# Reliability Analysis Update

Transmission Expansion Advisory Committee  
January 6, 2021

# Changes to Existing Projects

## B2832 : Presented in 1/12/2017 and 5/4/2017 TEAC

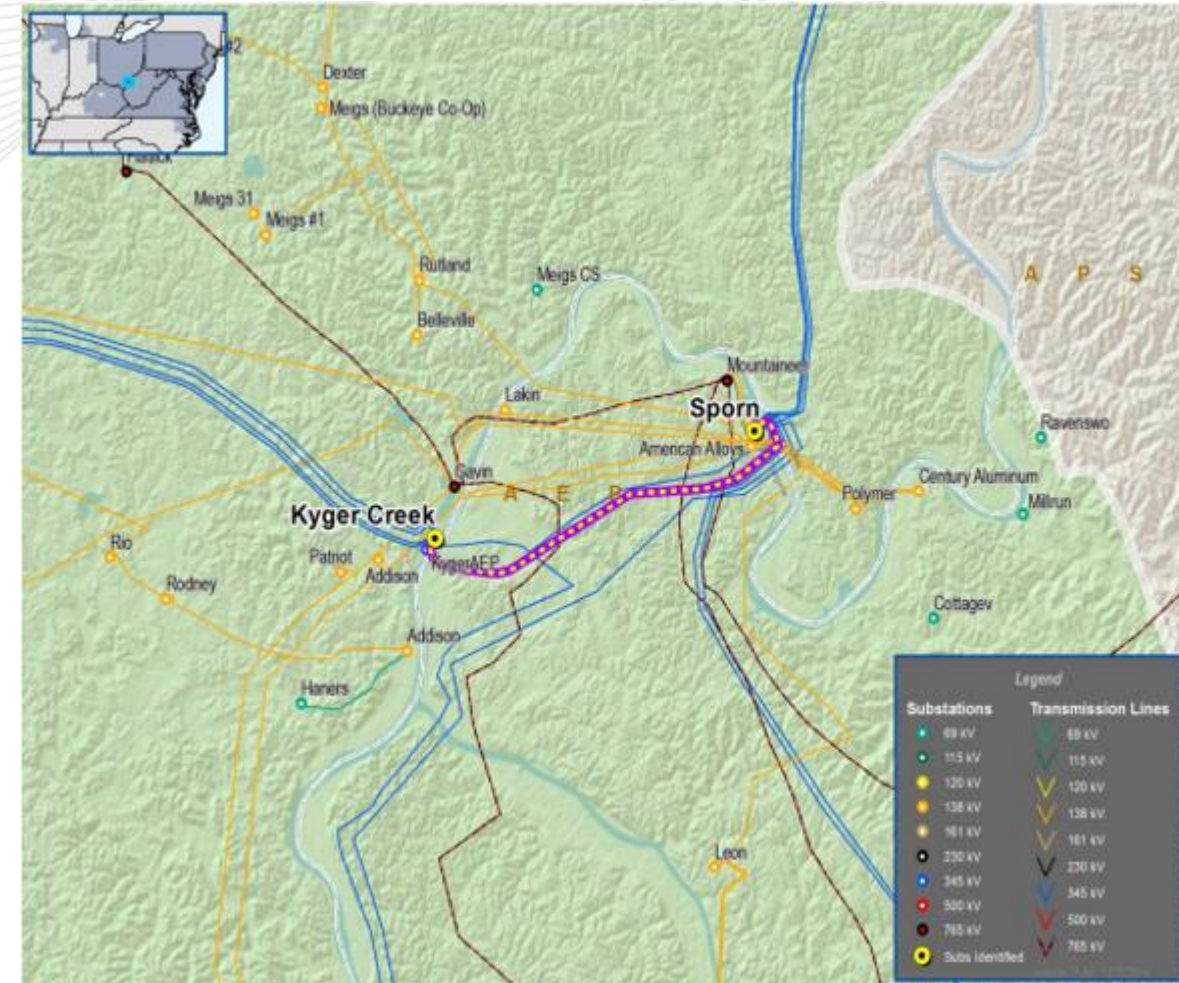
**New Scope:** Six wire the Kyger Creek to Sporn 345 kV circuits #1 and #2 and convert them to one circuit **and replace structures outside of the station to complete the six-wire scope.**

**Reason for the additional scope:** Original scope of work proposed the 6-wire solution to all be done within the station. After engineering work was completed, it was determined that work would be required outside of the station to replace structures to complete the six-wire scope. This additional work is reflected in the revised cost below.

**New Estimated Project Cost: \$3.0M**
